From: Manoj Nathoo (AT)
Sent: Wednesday, 30 April 2025 9:38 am
To: Siobhan O'Donovan (AT)
Subject: FW: Cross St/East St/Canada IFC

From: Putri Kusumawardhani (AT) <Putri.Kusumawardhani@at.govt.nz>
Sent: Monday, 24 February 2025 1:53 pm
To: Vaughn Scott (AT) <Vaughn.Scott@at.govt.nz>; Sophia Wang (AT) <Sophia.Wang@at.govt.nz>; Mathew Rudez (AT) <Mathew.Rudez@at.govt.nz>
Cc: Manoj Nathoo (AT) <Manoj.Nathoo@at.govt.nz>; Suresh Patel (AT) <Suresh.Patel@at.govt.nz>; Road Safety Engineering (AT) <RoadSafetyEngineering@at.govt.nz>
Subject: RE: Cross St/East St/Canada IFC

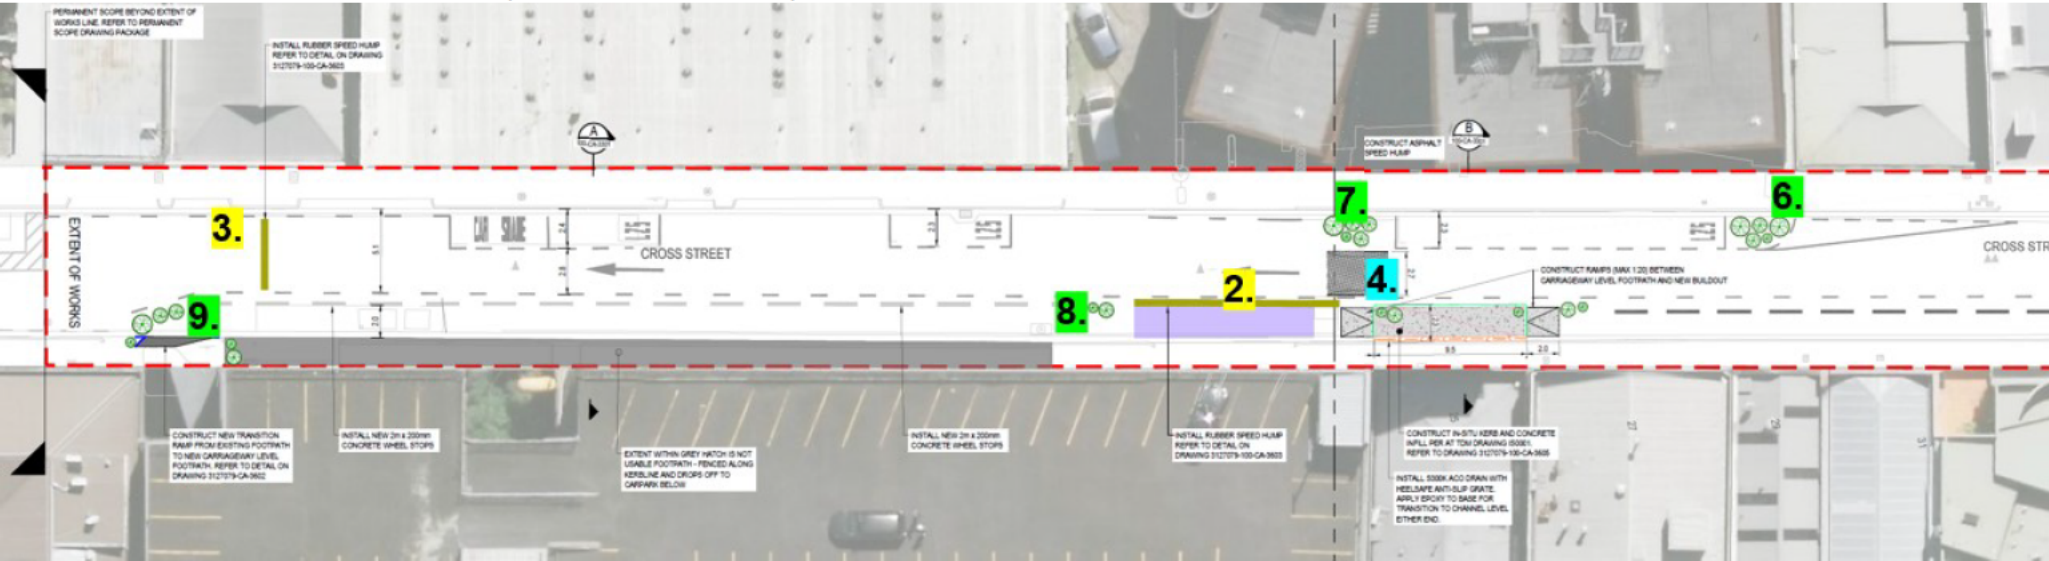
Based on the contour it seems manageable to maintain the speed along Cross St because no downhill-uphill forces. Removing the vertical features such as the speed hump and speed cushion on Cross St is acceptable if the operating speed can achieve the targeted speed around the station, which is a local road station access.

I would also like to point out that the **kerb build-out (horizontal features), still needs to be included on the design.**

It helps to create a clear delineation between the live traffic lane and the kerb-side loading or parking activity (when there is no loading/parking vehicle).

LEFT TURN FROM UPPER QUEEN STREET TO CROSS STREET

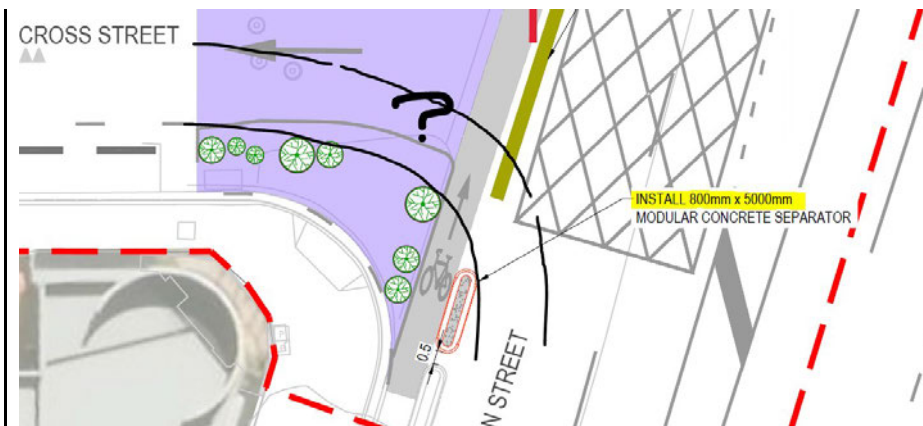
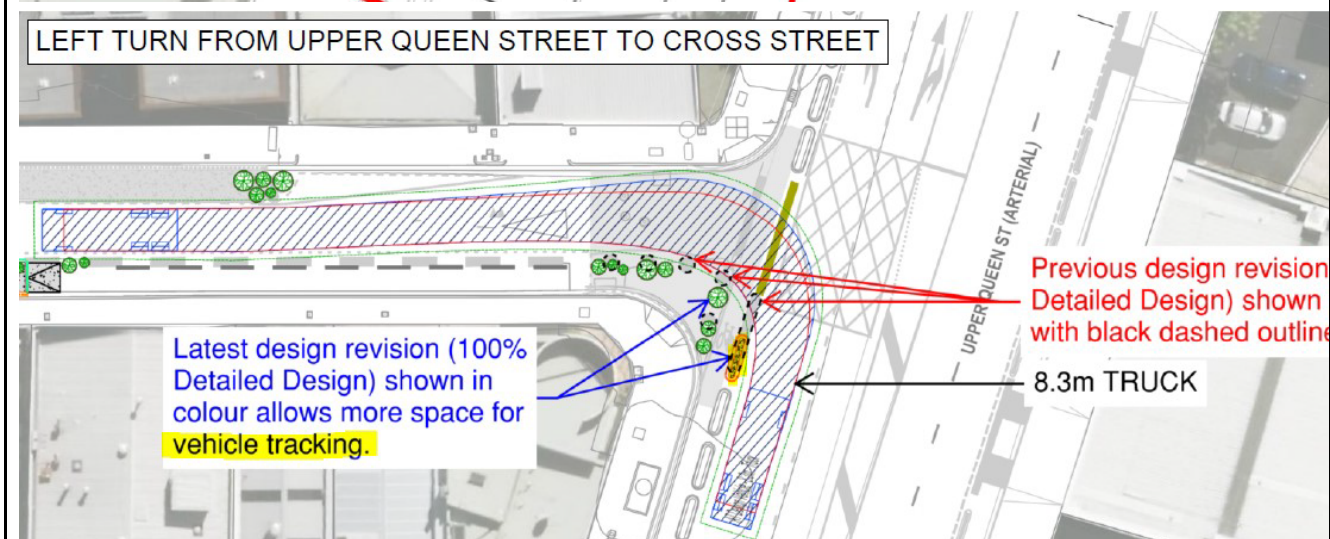
Based on my understanding, there are three types of vertical traffic or speed calming measures in place, as per my sketch below. Each of these components interacts with other design elements in the Cross St, and it's essential to consider them from a holistic perspective. It won't be effective to remove or maintain one of these measures without assessing the broader impact on the overall system. Please refer to the table for a detailed explanation of each component.

Rubber speed hump	Speed cushion
<p>1 and 3: main vehicle movement</p> <p>2: only for vehicle entr the car park building</p> <p><u>Notes</u></p> <p>Rubber speed hump#1 – <i>can be removed</i></p> <p>Located in the intersection, a tight turning radius has already helped reduce/manage the speed (retain the additional 800mm concrete separator and planter box #5).</p>	<p>4 (only one between $\pm 55\text{m}$ and $\pm 65\text{m}$ distance to both of speed hump)</p> <p>Subject to operating speed (however tend to agree on managing speed also can be achieved by having kerbside activity (loading zone, a</p>

Rubber speed hump#2 – can be removed

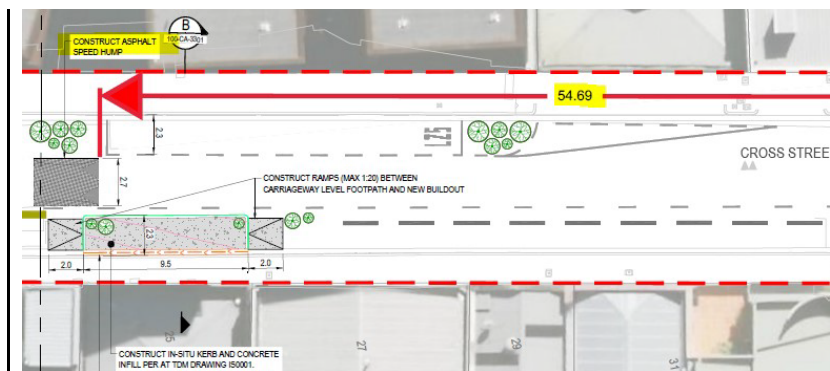
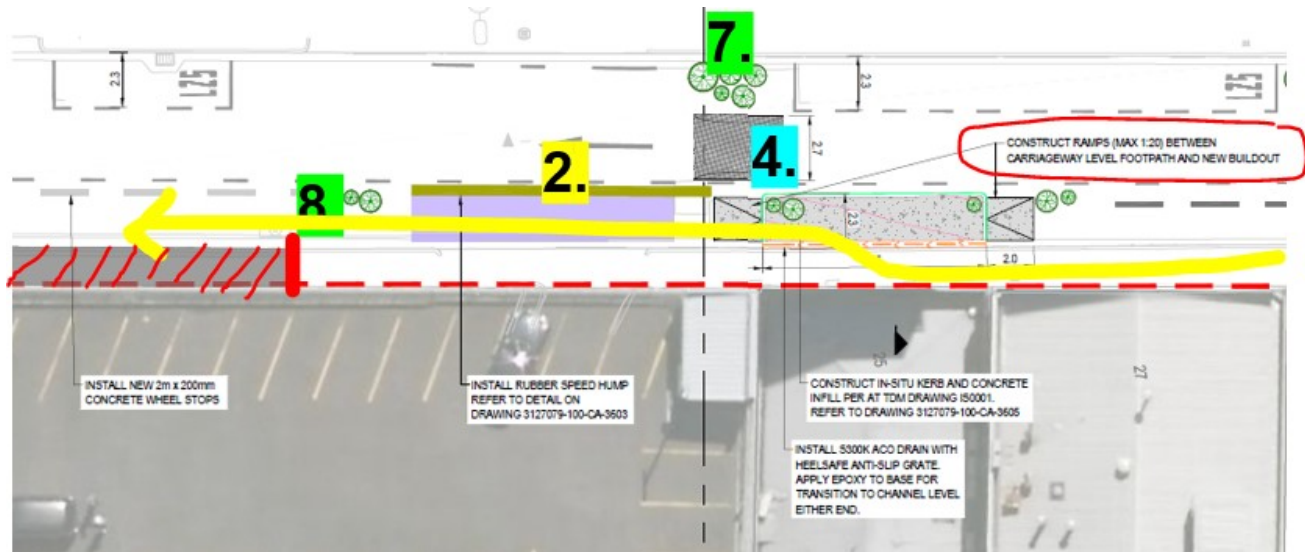
Previously served the shifting of pedestrians from the kerb build-out (see yellow line), the rubber hump is an additional design treatment to ensure drivers slowly enter the car park building.

Rubber speed hump#3

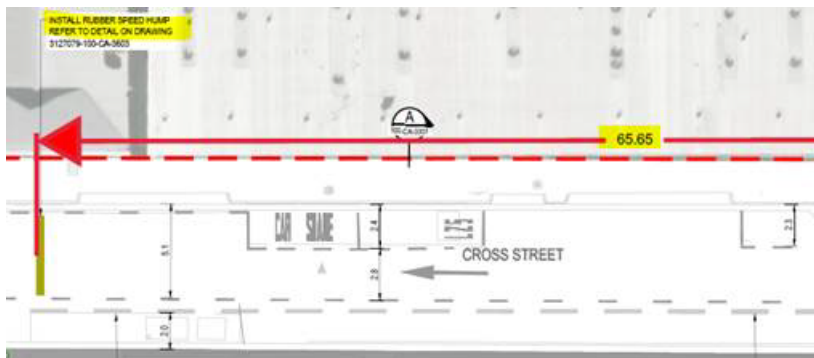
Vertical treatment to manage speed spacing every 60m for 30km/hr? **Subject to operating speed**
(however tend to agree more on managing the speed by narrowing the street using horizontal features such as planter boxes instead of vertical features - speed humps).

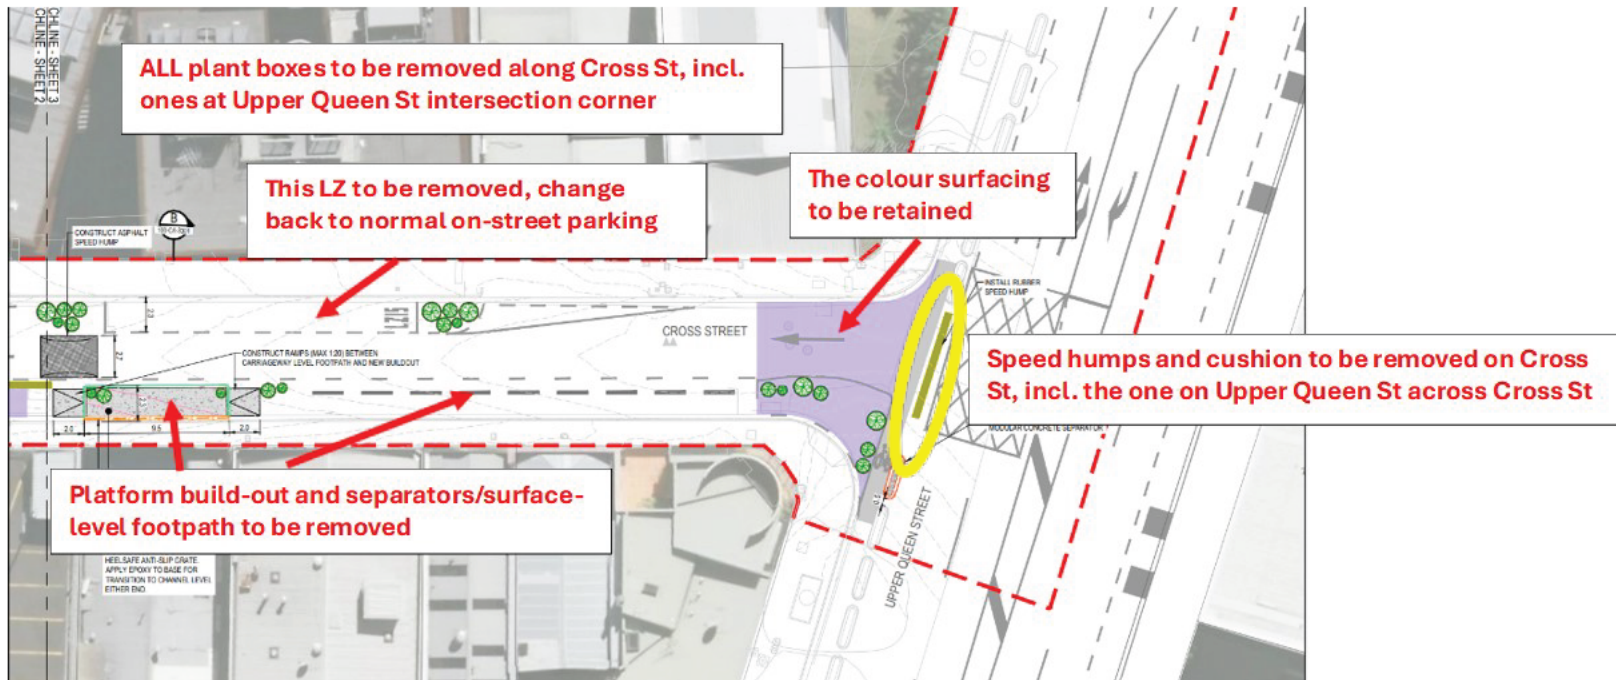
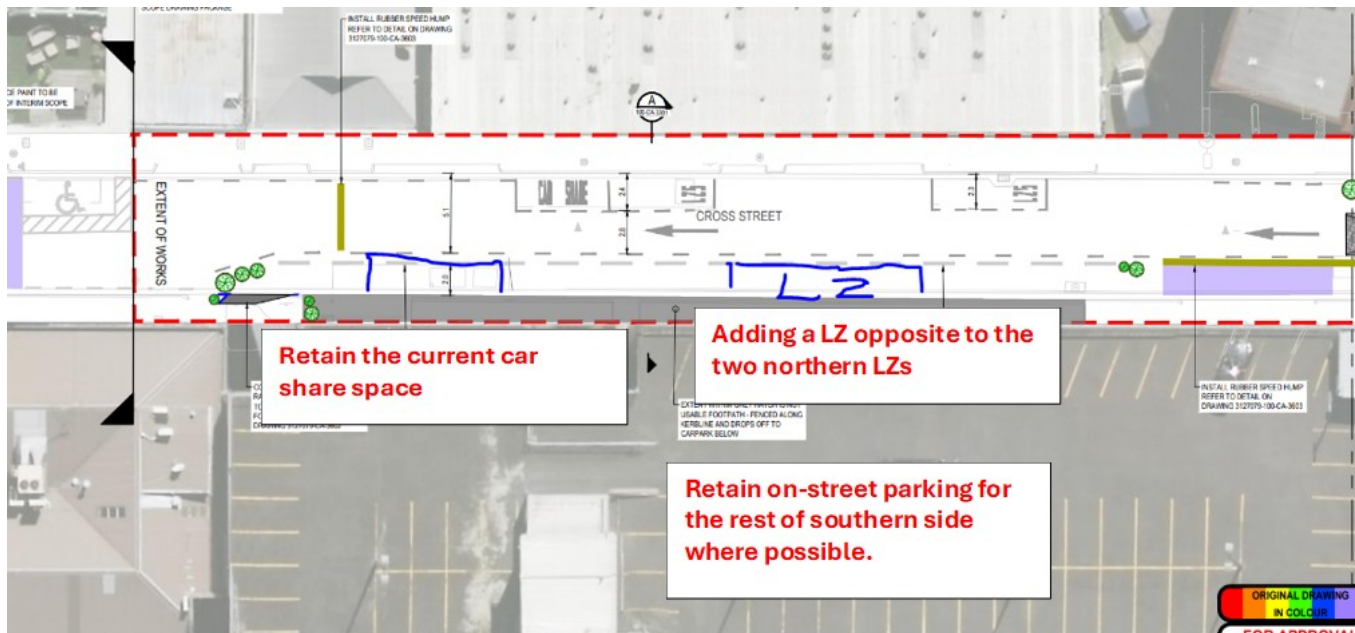
Another item the project team wish to draw your attention is that the speed hump across Cross Street at Upper Queen St intersection is to be removed (yellow circled in the snip below) along with other vertical devices along Cross Street, which was strongly suggested by Murray Burt due to the unpleasant experience and damage it may cause to the turning traffic, especially the delivery trucks. You can refer to pg. 6-7 in the Engineering Package attached for the original Cross St design, and the snips below showing the changes that were recommended and endorsed by Murray. The project team would like to check with you as the key SMEs to this particular item, if any of you have any major concern on the changes. If yes, please kindly provide us a strong justification for keeping any original proposal, for our further engagement with Murray Burt and project PCG.
